PEUGEOT/CITROËN THERMOSTAT REDESIGN TO OVERCOME OVERHEATING ISSUES

Issue Date: 23/09/19 Issue Number: COTB0024F

APPLICATION : Citroën C4, DS3, DS4, DS5, 207, 208, 308, 3008, 5008, RCZ

APPLICABLE REFERENCES : FTK100 / FTK486

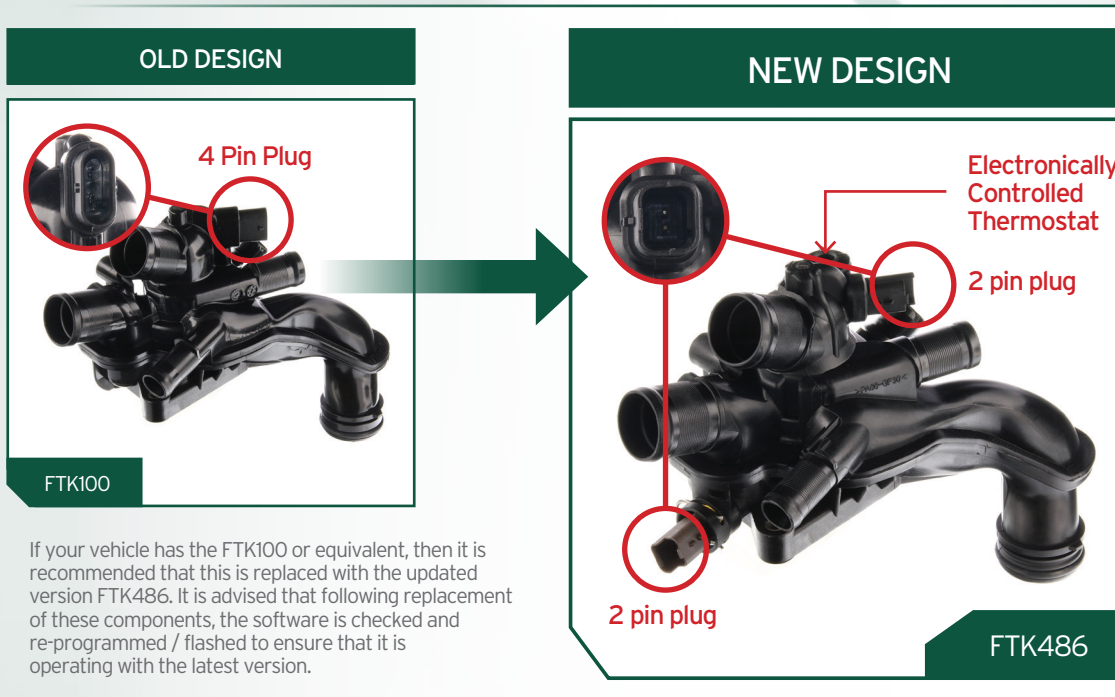
Due to an increase in overheating issues & symptoms such as an erratic temperature gauge, erratic running, radiator fan run-on, or poor heater function in the above vehicles, the O.E.M. have modified the design of the Thermostat housing. Following the O.E. specification, we have replaced the old design FTK100 with the new latest design FTK486. The latest design benefits from an electronically controlled thermostat, a reinforced structure, and a new configuration of sensors.

We have highlighted the key differences below so that you are clear that the latest part; although visually different to what may be on the vehicle, is in fact the correct product.

The modified version has two 2 Pin connectors instead of the one original 4 Pin connector, therefore, a new cable may also be required to carry out the modification.

New Cable: FTS3091 - Thermostat Wiring Harness
